Subject: Quad Cities Station Units 1 and 2  
Dresden Station Units 2 and 3  
"Response to NRC Request for Additional  
Information Pertaining to 10 CFR, 50.62  
Anticipated Transient Without Scram (ATWS) Rule"  
NRC Docket No 50-254 and 265 and 50-237 and 249

REQUEST FOR ADDITIONAL INFORMATION ON  
ATWS REVIEW RELATED TO ALTERNATE  
ROD INJECTION (ARI) AND  
RECIRCULATION PUMP TRIP (RPT) SYSTEMS  
QUAD CITIES STATION - UNITS 1 & 2  
DRESDEN STATION - UNITS 2 & 3

**Figure 1. Reactor Protective System Distribution**  
 Dresden Units 2 & 3 AND QUAD CITIES 1 & 2

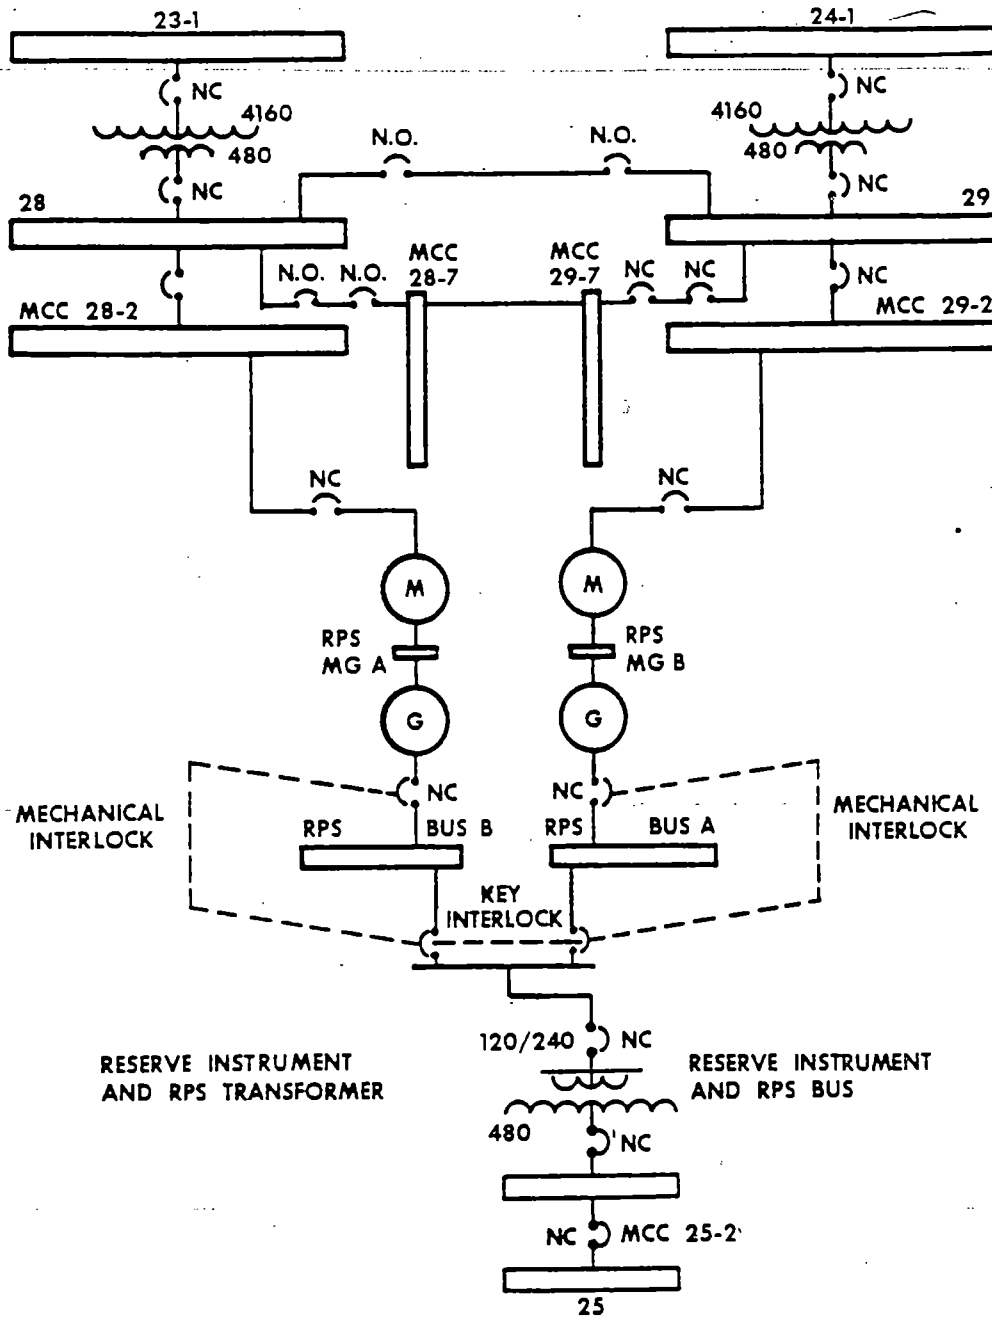
- 2.0 Provide electrical one-line diagrams to demonstrate the electrical independence between the ARI system and the Reactor Trip System (RTS), and the capability to perform the ARI function during the loss-of-offsite power event.

For Dresden Units 2 & 3 and Quad Cities Units 1 & 2, the ARI design is safety-related and segregated into two electrical divisions; namely Division I and Division II which are maintained separate. The RTS at the Dresden and Quad Cities stations is the Reactor Protection System (RPS) which is a four-channel electrical arrangement which has individual channel separation. All four RPS channels are routed in separate conduits and never routed with divisional segregated circuits.

The power for the RTS (i.e., RPS) is 120V ac from the RPS motor generator sets. The ARI system will operate fully from non-interruptible dc (i.e., onsite station batteries) which are independent from the RPS power. Thus the ARI system will perform its function during any loss of offsite power event.

Note that both the RPS & ARI systems are normally fed from ac sources, where for the ARI system ac is converted to dc for power to it. Note, however, that a loss of offsite power the ARI system will be fed from the non-interruptible 125V dc battery. While the RPS will be fed from the diesel generators.

The electrical one-line diagrams that demonstrate the electrical independence between the ARI system and the reactor protection system are attached to the end of this document.
